Response to review by Reviewer #6

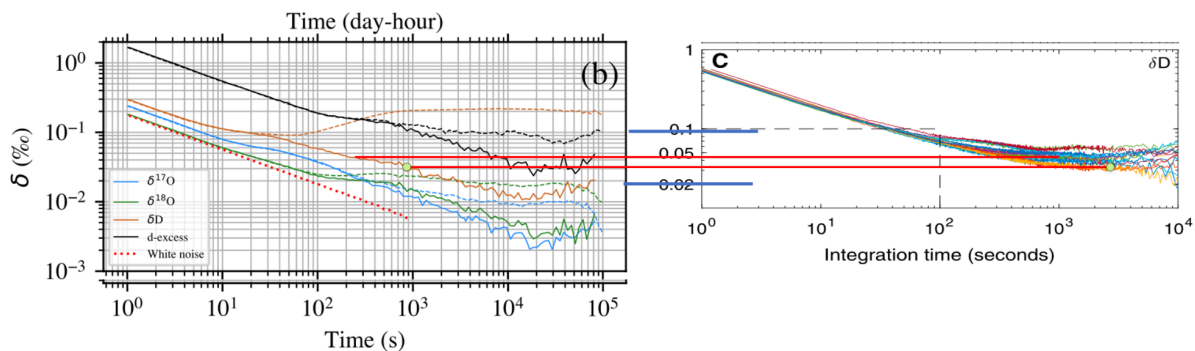
In 265: please see comments above -- the performance shown here is excellent, but it is not significantly different from Steig et al 2021, which does not trim data as extensively as is shown

here or have nearly as much time for each run. this (and the comparison with fig 8) suggests an increase in memory for this system, which should be discussed in more detail, if only to demonstrate that it can be managed for the applications promised.

While we agree that for integration times up to 10^3 there are only a smaller improvement in our system compared to Steig et al. 2021. The average performance for δD at 10^3 corresponds to our integration at $2e2$. However, while the Allan Deviation in Steig et al. 2021 does not improve after $1e3$, ours continue to improve until $2e4$. See figures below focusing on δD .

The reviewer is however correct in pointing out that the memory effect seems significantly larger than in the system presented by Steig et al.. Having worked with the similar system system (Jones et al. 2017) as discussed by Steig et al., I do also believe that the system by Jones could have a smaller memory effect than ours. However, it comes at a cost of a 10-20 time higher flow rate.

However, a direct comparison in memory effect between the system used by Steig et al. 2021 and our system is not possible due to lack of information of which standards were measured before the run used to generate the Allan Deviation. We speculate that the Allan Deviation is generated based on the lab water run depicted in Figure 1 and that the run depicted is typical. This means that a idealized step change is equal to about 25 per mil in $\delta^{18}O$. This should be compared to the step change of about 55 per mil in $\delta^{18}O$ applied in our setup.

It is furthermore not clear to us, how much of the data is removed after the step change in Steig et al. in order to remove the effect of memory in the system. In our figure 3 (shown below) we depict the influence of memory effect, when not removing the first 16 hours as dashed lines. Not removing any data after a step change is of course not realistic, but we do this to illustrate the influence of the memory effect on the Allan Deviation.
